DRAINAGE INFORMATION SHEET

PROJECT TITLE: Albuquerque Gymnastics ZONE ATLAS/DRNG. FILE #: G-21 / ~~DRG~~ 12C.1

RE: DRAINAGE PLAN FOR ALBUQUERQUE GYMNASTICS
(G-21/D120) RECEIVED FEBRUARY 27, 1985

TITLE: LOT II-B BLOCK 17, MESA ARRIBA ADDITION
DRAINAGE & GRADING PLAN

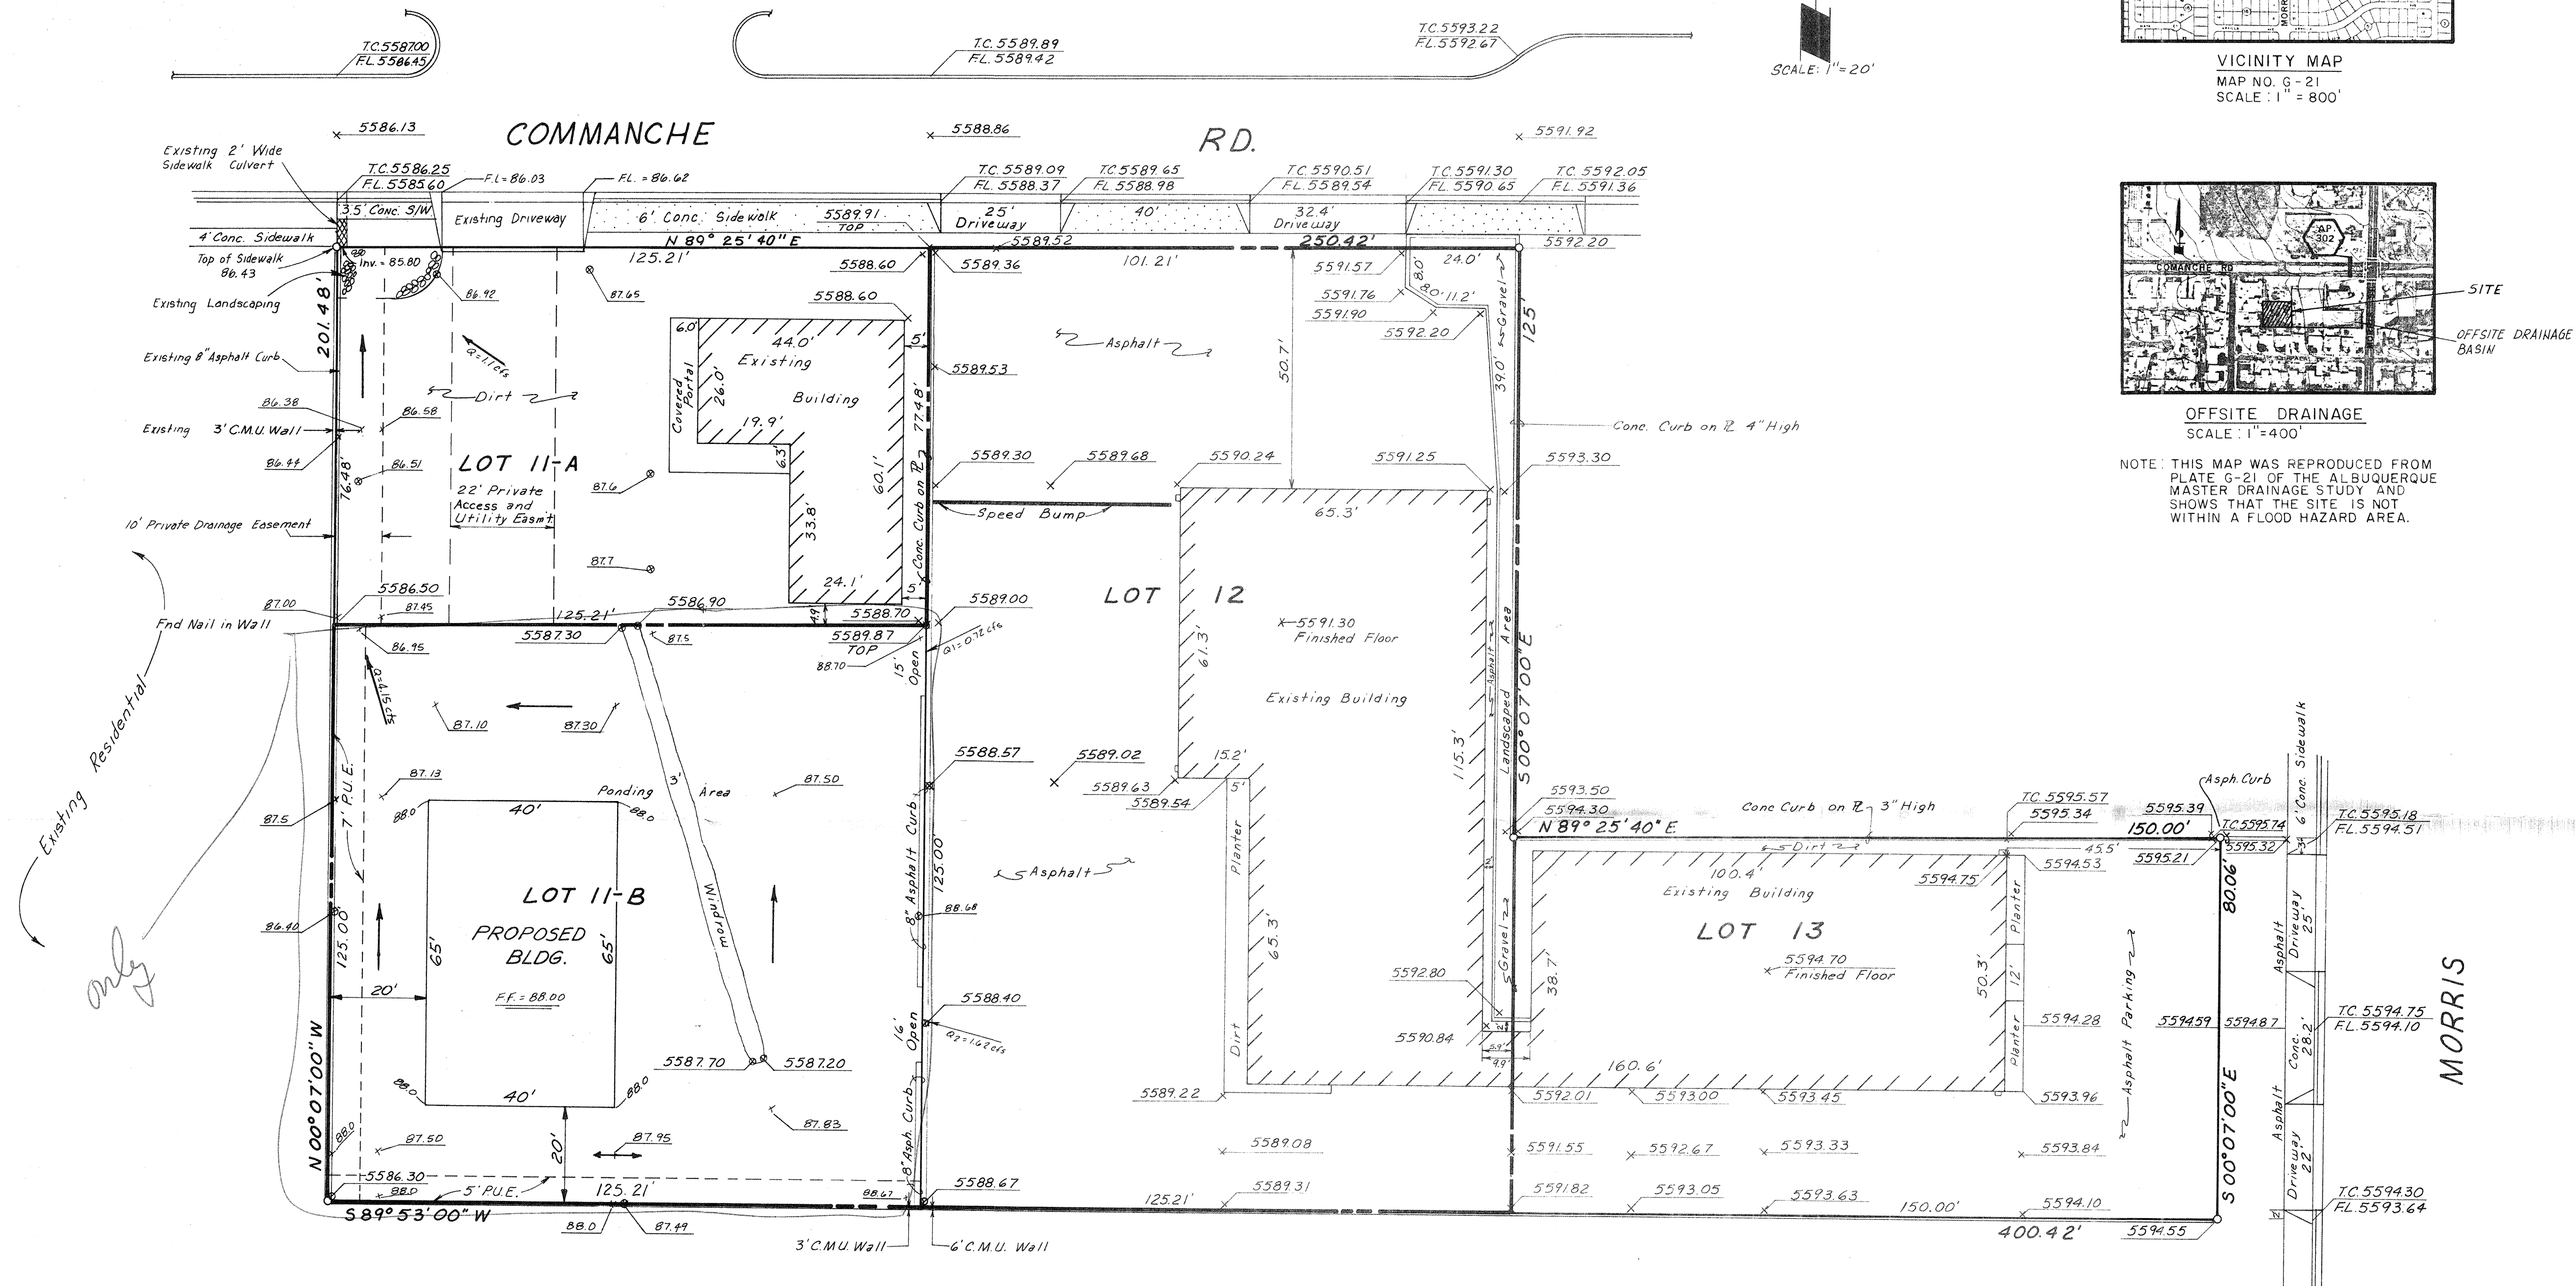
The referenced plan dated February 27, 1985, is approved.

Please attach a copy of this approved plan to the construction set prior to Hydrology sign-off.
